PCN-147986

Product Change Notice

Alternate manufacturing site for ChipLEDs part number listed below.

Description and Extent of Change:

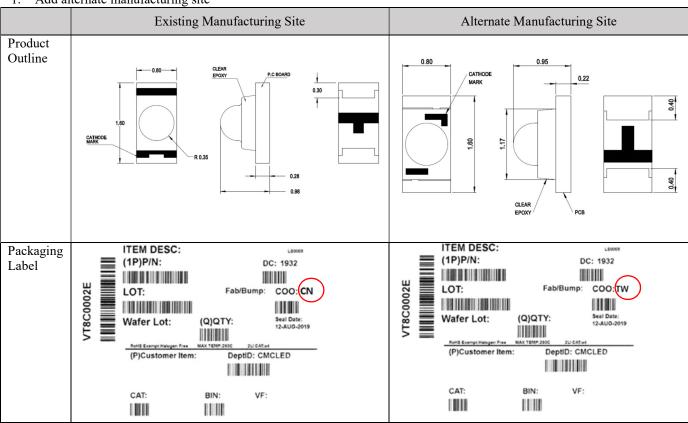
The selected manufacturing site is qualified per Broadcom's qualification process.

1. Add alternate manufacturing site

Performance update for HSMQ-C320
 Viewing angle change from typical 50° to typical 40°.
